**Re: 3440 2nd Street NW
Grading and Drainage Plan
Engineer's Date 11-24-14 (G14D087)**

**Re: 3440 2nd Street NW
Grading and Drainage Plan
Engineer's Date 10-31-14 (G14D087)**

Re: Office Warehouse, 3440 2nd Street NW
Traffic Circulation Layout
Engineer's/Architect's Stamp dated 11-03-14 (G14-D087)

Re: Office Warehouse, 3440 2nd Street NW
Traffic Circulation Layout
Engineer's/Architect's Stamp dated 10-20-14 (G14-D087)

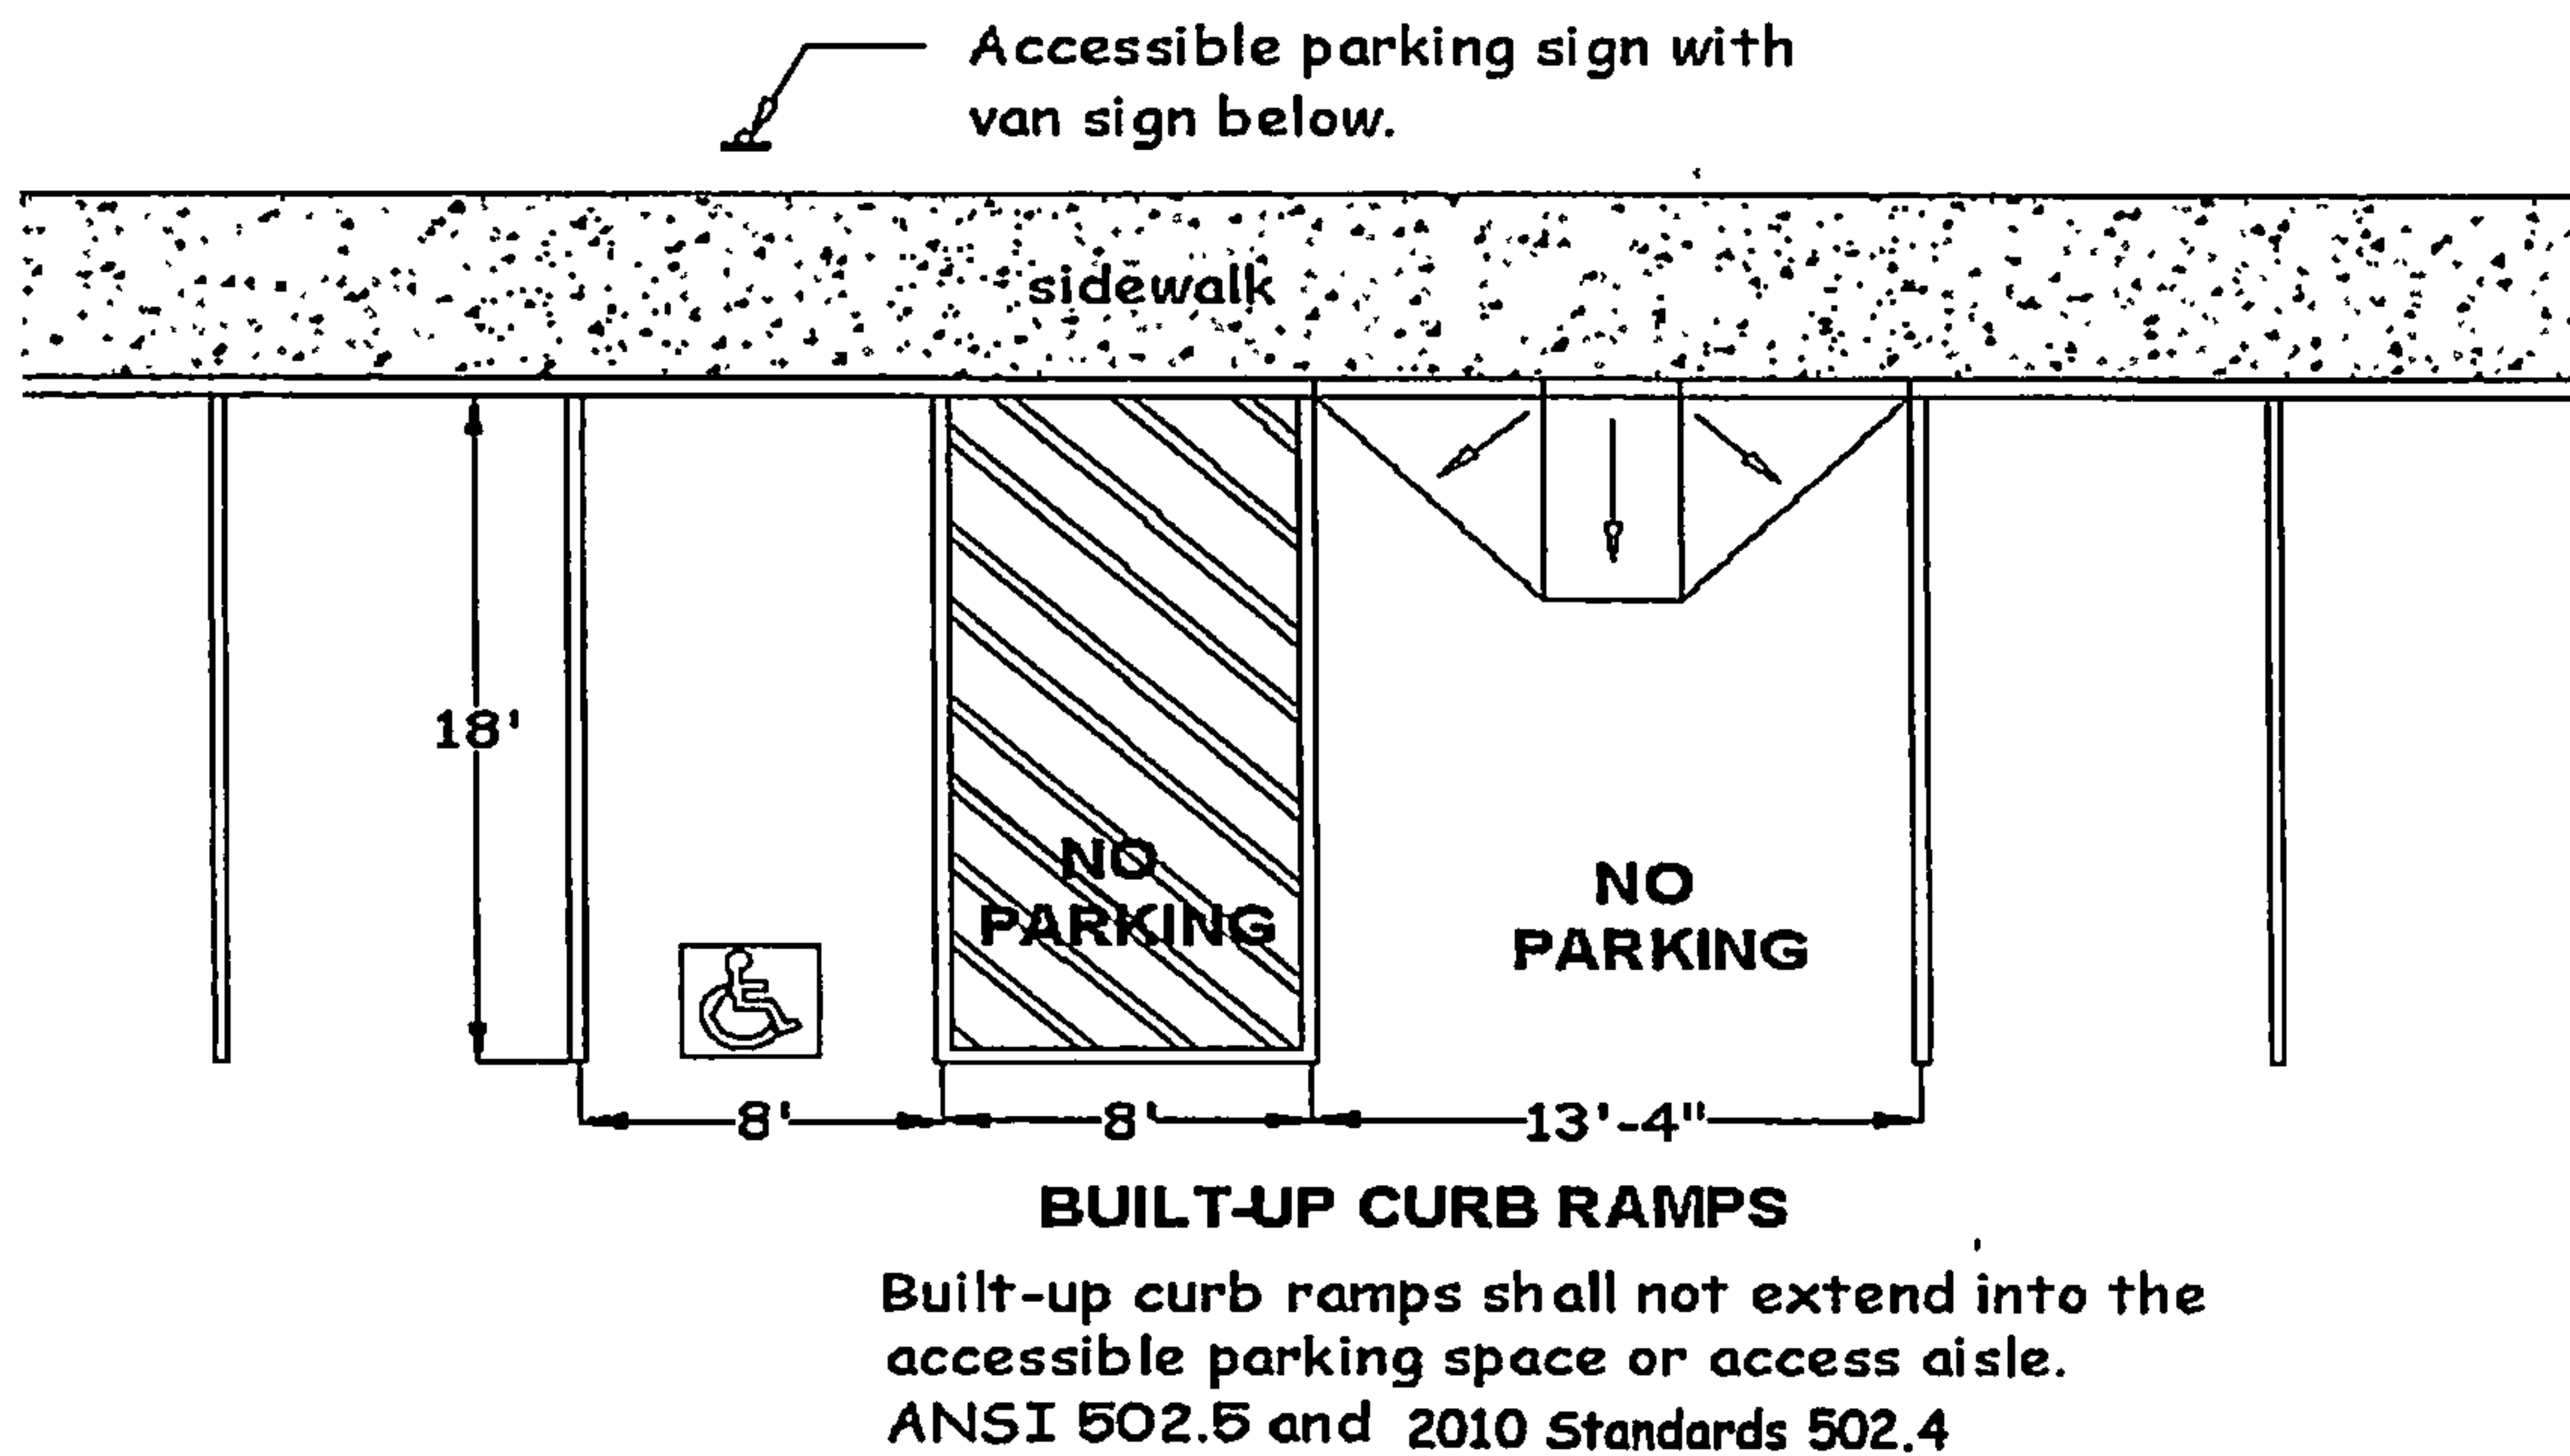
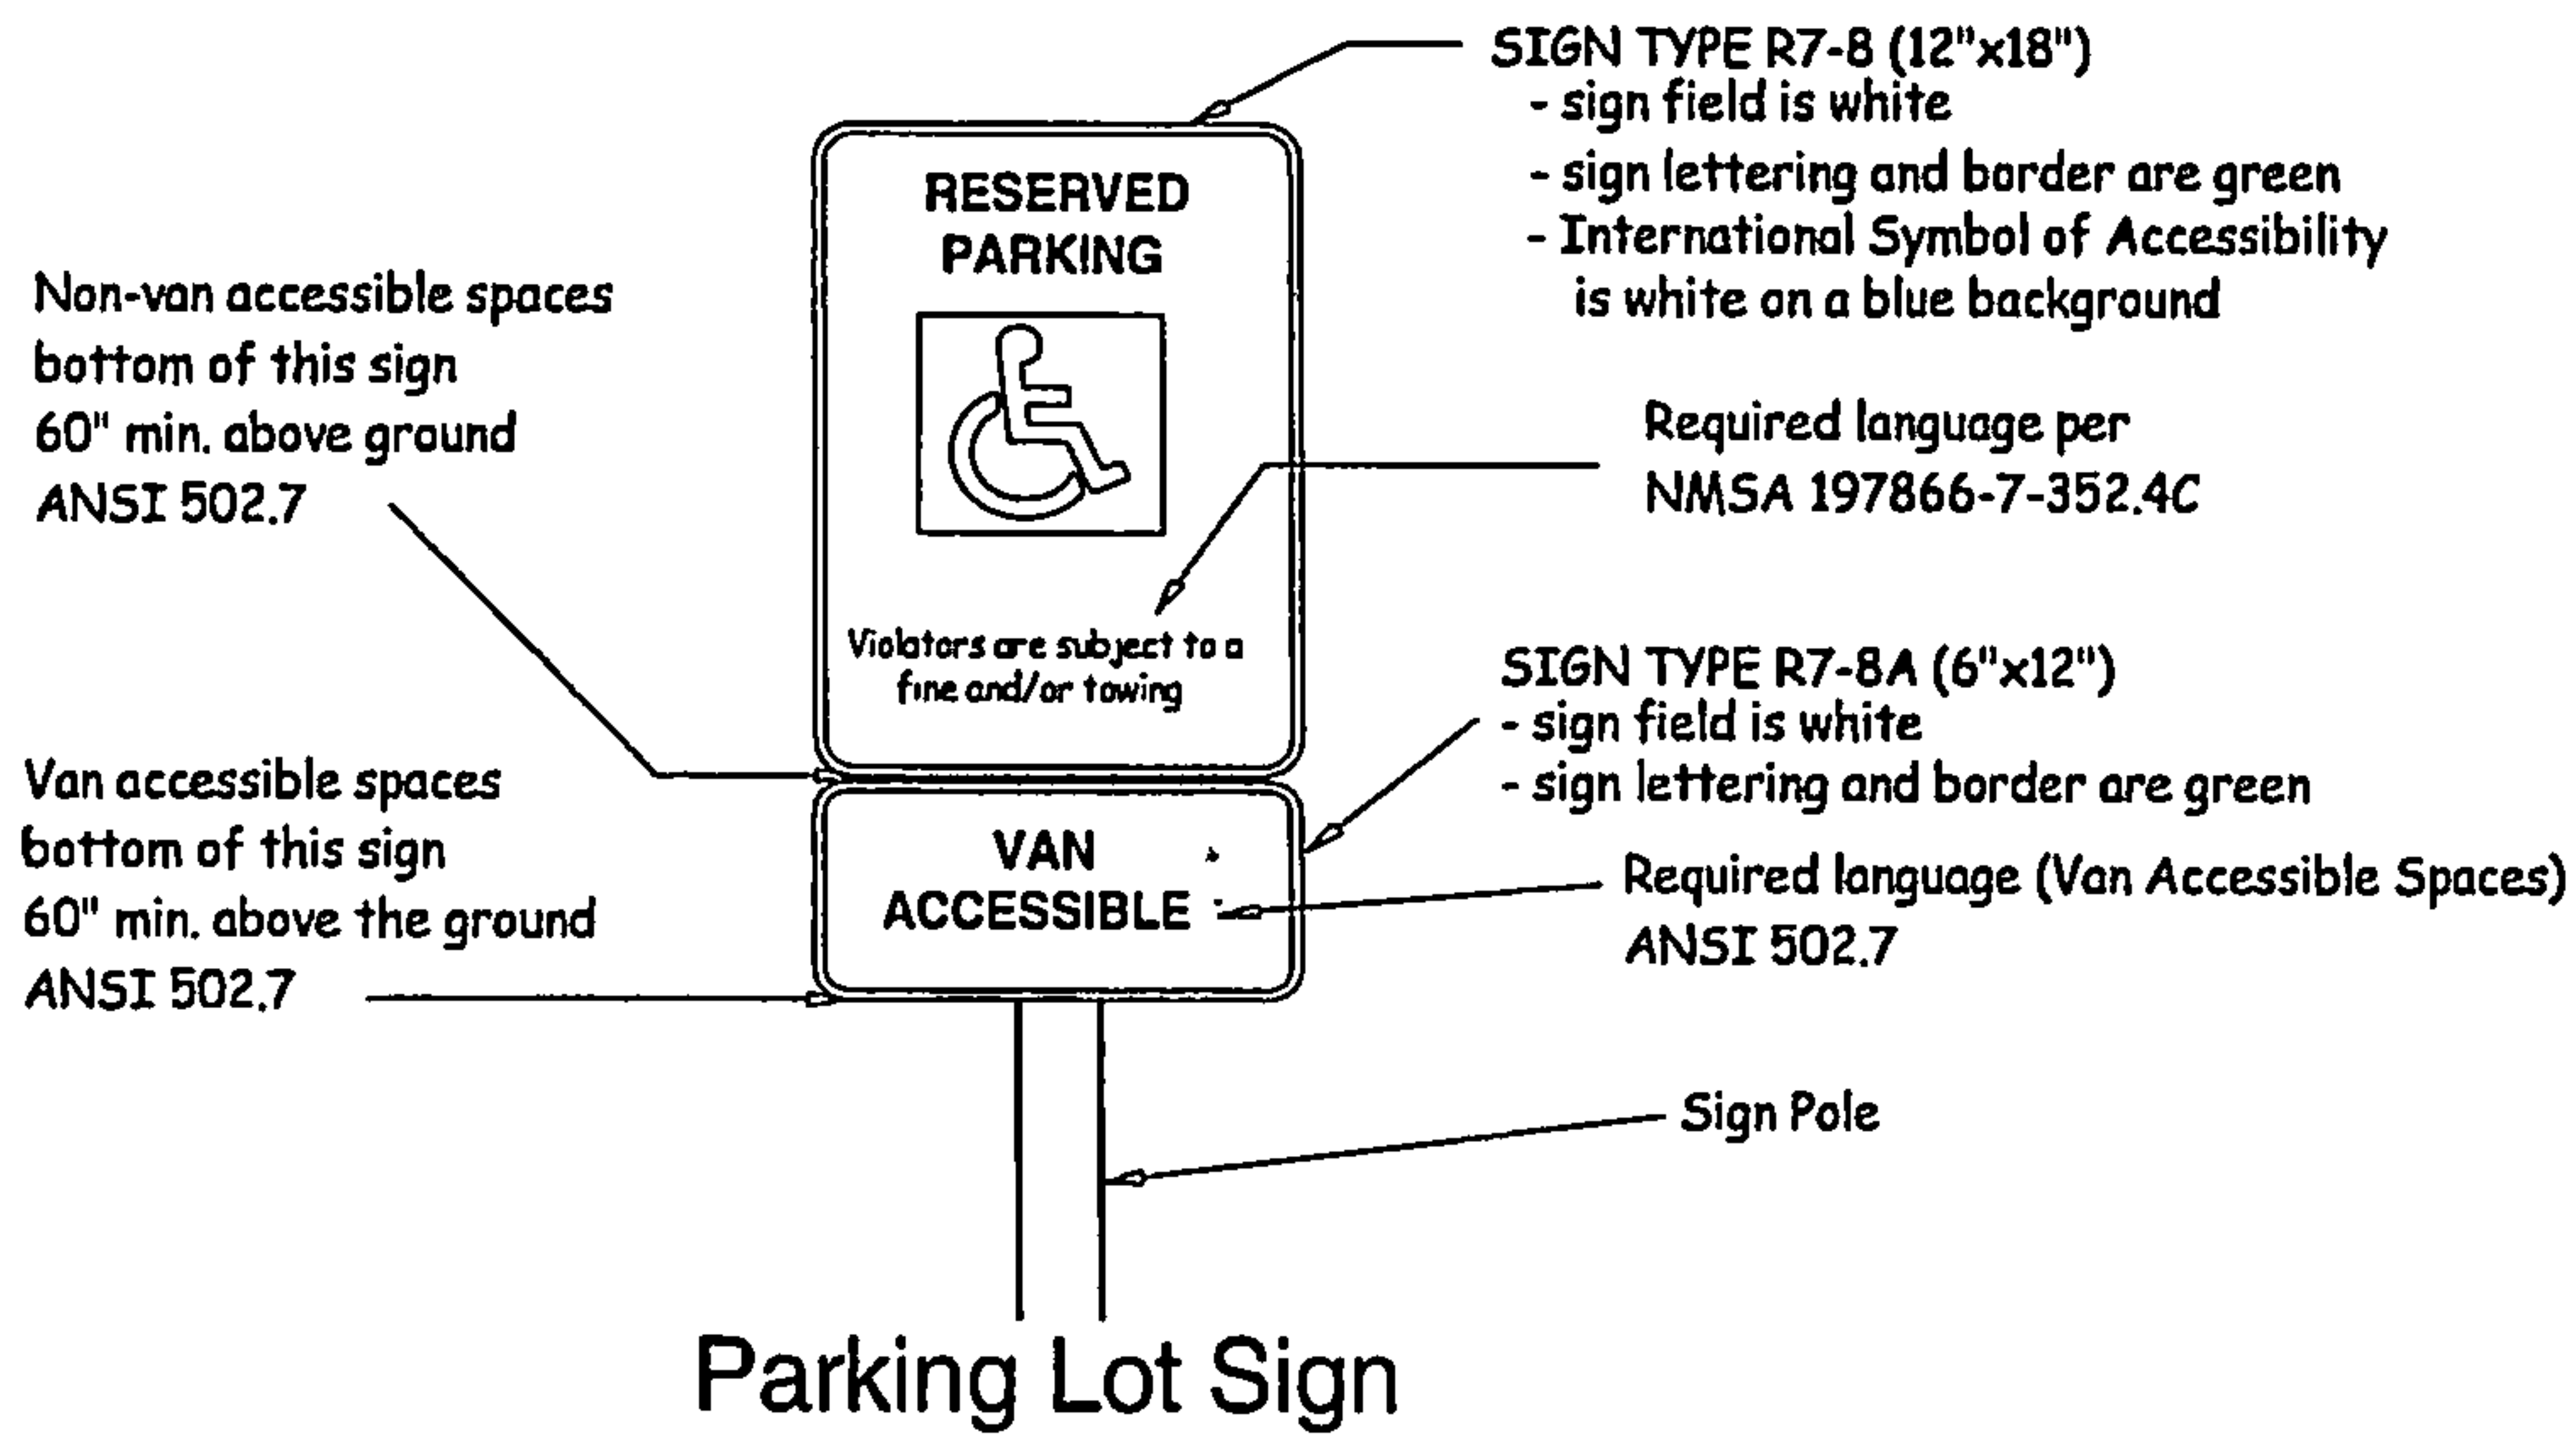
Shawn, I have received the updated site plan for the subject project but still have the following comments:

1. I do not see Keyed Note 23 on the plans. I think you meant to put in Keyed Note 23 where keyed note 22 is shown for the van accessible space.
2. The site plan needs to be clear that both the van accessible space and the handicapped space are asphalt. Right now only the handicapped space is shown to be asphalt. It may be more clear if some type of hatching/lineweights are shown to differentiate the asphalt area from the remaining area.
3. The "No Parking" words need to be placed in the van accessible aisle, not where the handicapped people park (See attached scan).
4. Also see the attached scan for exact required language on the handicap sign. The "van only" sign needs to be shown as "van accessible".
